P5028A-03B-S

# Safety Service Note

# P5028A Keysight Streamline USB Vector Network Analyzer

"POTENTIAL BURN INJURY (HIGH TEMPERATURE) HAZARD"

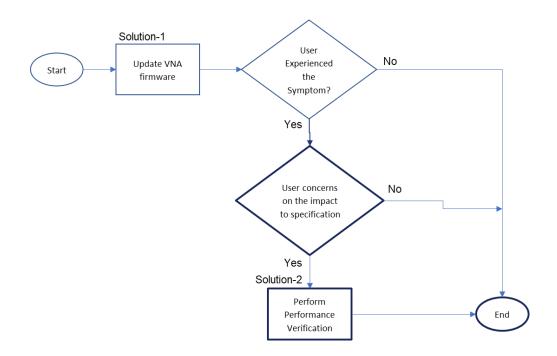
VNA fails to start with the following symptoms.

- 1. LED indicator (below circle) turns red.
- 2. cooling fan does not work
- 3. If user leaves the VNA with this LED indicator red without turning off power switch, it continues to overheat and becomes too hot.

Solution-1: Update VNA firmware by user

Solution-2: Perform Performance Verification by Keysight

- 1. Install the latest VNA firmware Rev. A.15.40.13 or newer on users' controller PC(s). The latest firmware enhanced the thermal fan control mechanism.
- 2. Once the latest firmware is installed, proceed with the restart of both **controller PC** and **VNA**.
- 3. Launch the VNA firmware. Ensure VNA powers up and launches into firmware correctly after firmware update is done.
